**RE: Minor change application
Proposed extension to multiple dwelling
15 Barter Avenue (1 Lamette Street), Holland Park
Council reference: A006154855**

We are writing in relation to the abovementioned development approval, to request a change to the approval pursuant to section 78 of the *Planning Act 2016* (the Act), in accordance with provisions of section 81 (minor change).

Figure 3. Proposed section showing revised carport.

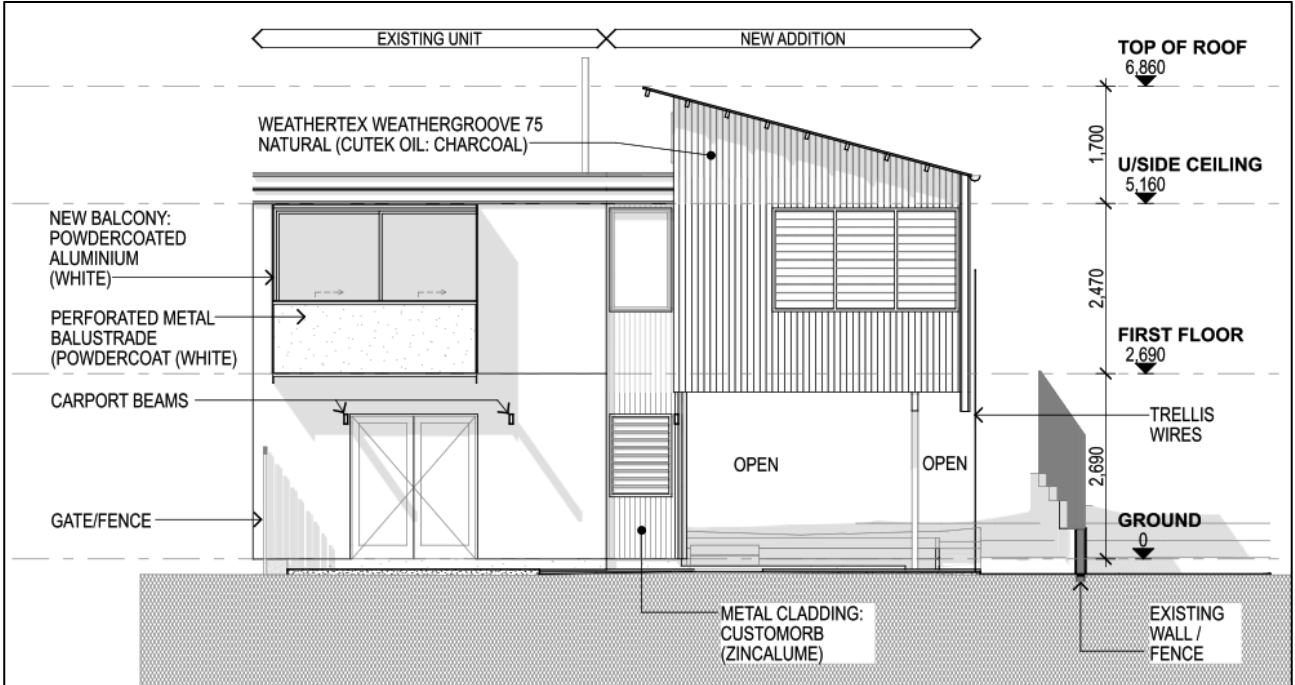
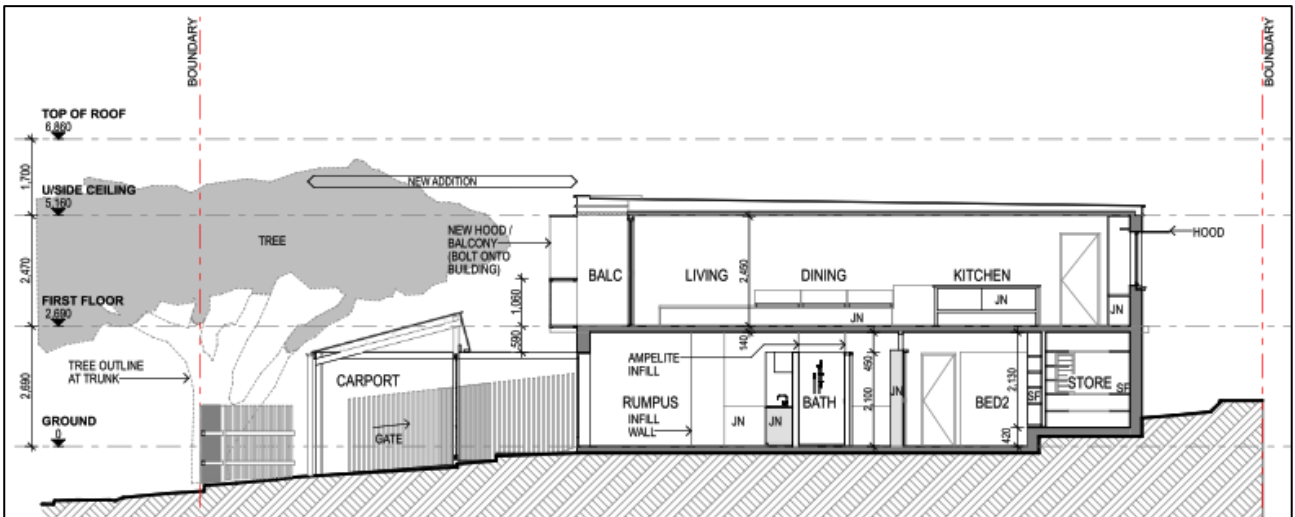
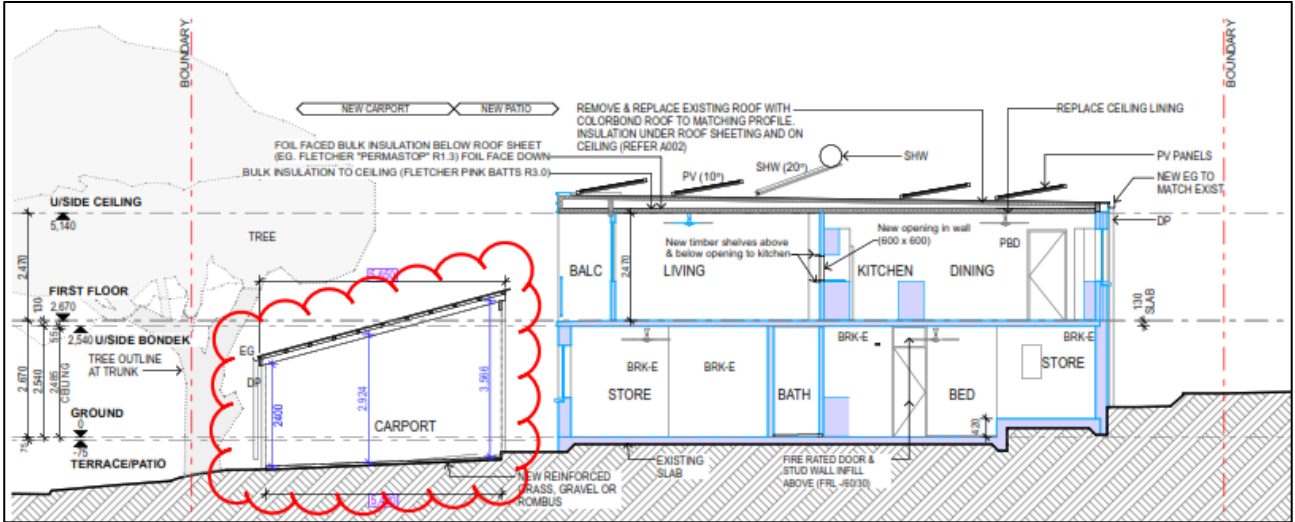
The proposed change includes widening the proposed carport to accommodate two cars. The open construction and skillion roof form of the approved design are maintained.
